Documentation Update

Allen-Bradley BASIC Module User's Manual (Cat. No. 1771-DB)

Publication 1771-6.5.34, BASIC Module (Cat. No. 1771-DB) User's Manual, dated July, 1987.

Publication 1771 6.5.34 DU1 — March 1990

Figure 4.3B
Cable pinouts for connecting a 1771-db BASIC Module (Program Port) to a 1770-TA, Series A Monitor (1770-FC or 1770-FA keyboard).

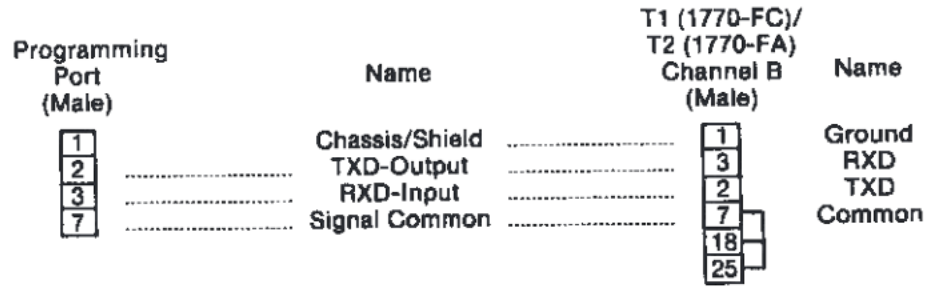
Important: Use the firmware revision level shown on the screen when the T3/T4 first powers up. Do not use the revision levels listed on the bottom of the keyboard or back of the T3/T4.

Figure 4.6
Cable pinouts for connecting a 1771-DB BASIC Module to a 1770-HC Printer

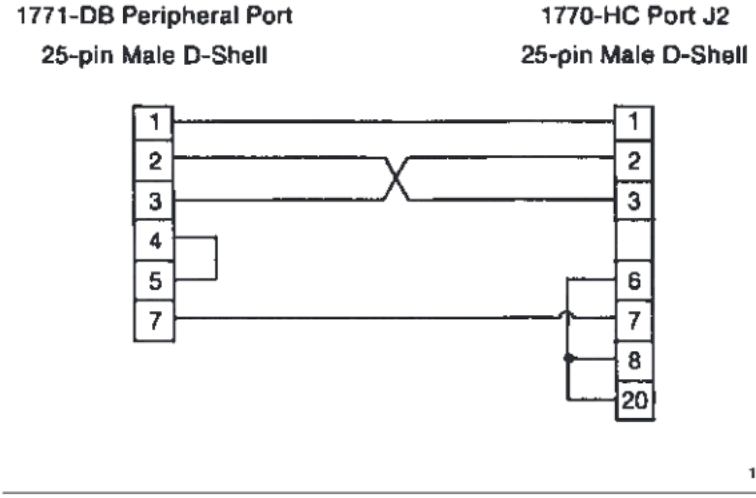
Replace Figure 4.6, "Cable Connection to 1770-HC Printer" with the following figure:

Important: This cable does not support hardware handshaking.
